Stakeholder Feedback to MGSTF Design Component Prioritization

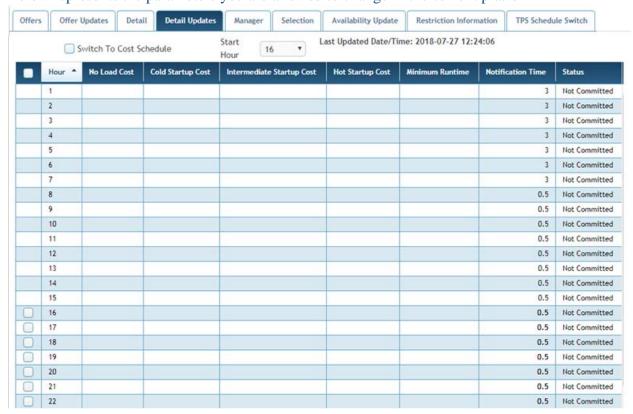
One of the places where the new unit model effort intersects with other PJM initiatives is in the proposal at the EPFSTF to redesign the synchronized reserve market processes. PJM has observed for some time that their calculation of available Tier 1 reserves is substantially in excess of observed response during many synchronized reserve activation events. One reason for this persistent difference could be limitations in GO ability to model unit operational features within their segmented dispatch curves, such as 1 BFP/2 BFP limits, coal mill switch points or augmented operating modes on CC plants.

To the extent that PJM-GO evaluations show that modeling limitations contribute significantly to the observed difference in calculated versus delivered Tier 1 response, it would be worthwhile for the MGSTF to consider whether minor, straightforward data items could be added to the current model to identify unit dispatch breakpoints and improve PJM's estimate of available Tier 1 resources on a real time basis.

Below represents the parameters you are allowed to change in the current platform

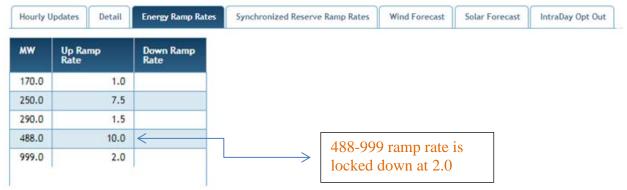
Problem: Fuel switching (for duel fuel units) while possible with hourly offers, doesn't allow for all parameters to be changed. While you can change your actual offer curves, you can also change the startups, no load, min runtime, and notification time. **However, you cannot change your max runtime or actual fuel type for the 99 price-based curve**. Therefore, if you are awarded on your 99 curve, there is no way to change fuel type without switching to cost.

In our example of 99 price-based curve on oil with max run of 4 hours. There is no way to change specific hours to gas; the max run time cannot be switched to 16 hours. Even though the price reflects gas the scheduled detailed page would still reflect oil (with max run time of 4 hours).

You can currently change your price offer to "reflect" two fuel types, but the details of the 99 curve will only be one fuel type. Therefore if you specify "Oil" as your fuel type, it has a max run time of 4 hours. But in real-time, you find out you can run 10 hours of gas. You change the offers down to reflect that gas, but PJM is limited to running the unit for 4 hours because you couldn't change the max run time.

Suggested change; be able to model fuel types per hour.
